Access Compliance Report

Public Rights-of-Way

(Curb Ramps)

Intersection ID: 28743	Main Street: CHASTAIN_WALK_DR	Cross Street: MT_HOLLY-HUNTERSVILLE_RD	Location: SW
ADA ID: 90E168CA77DE	Ramp Type: Perp	Initial Pass/Fail: Fail	Overall Compliance: No
Severity Score: 12.5			
Codes/Mitigation Info/Possible Solution		Field Measurements/Component Compliance

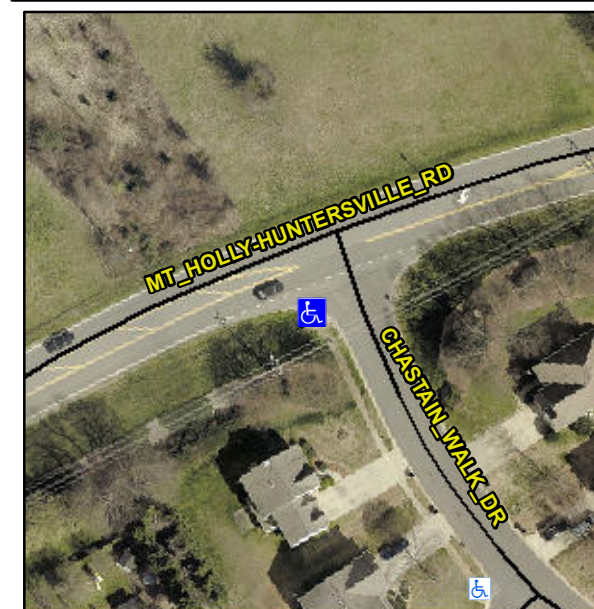
R304.2.2

Compliance	Description	Data	Compliance	Description	Data
N/A	Ramp Length (in)	47.0	No	Ramp Slope (%)	11.0
Yes	Ramp Width (in)	80.0	Yes	Ramp XSlope (%)	0.7
N/A	Flare Type LT	N/A	N/A	Flare Type RT	N/A
N/A	Flare Slope LT (%)	N/A	N/A	Flare Slope RT (%)	N/A
N/A	Flare Traversable LT?	N/A	N/A	Flare Traversable RT?	N/A
N/A	Landing Length (in)	N/A	N/A	DWS Provided?	N/A
N/A	Landing Width (in)	N/A	N/A	DWS Contrast?	N/A
N/A	Landing Slope (%)	N/A	N/A	DWS Length (in)	N/A
N/A	Landing X Slope (%)	N/A	N/A	DWS Full Width?	N/A
N/A	Landing Curb? (Y/N)	N/A	N/A	DWS Offset (in)	N/A
N/A	Shared Landing?	N/A			
N/A	Gutter Ponding?	N/A	N/A	Gutter Slope (%)	N/A
N/A	Gutter Lip Ht (in)	N/A	N/A	Gutter X Slope (%)	N/A
N/A	Painted X Walk1?	No	N/A	Painted X Walk2?	N/A
	X Walk 1 Direction	To N		X Walk 2 Direction	N/A
N/A	X Walk 1 Width (in)	N/A	N/A	X Walk 2 Width (in)	N/A
	X Walk 1 Slope (%)	8.2		X Walk 2 Slope (%)	N/A
	X Walk 1 X Slope (%)	0.9		X Walk 2 X Slope (%)	N/A

Remove & Replace Entire Ramp.
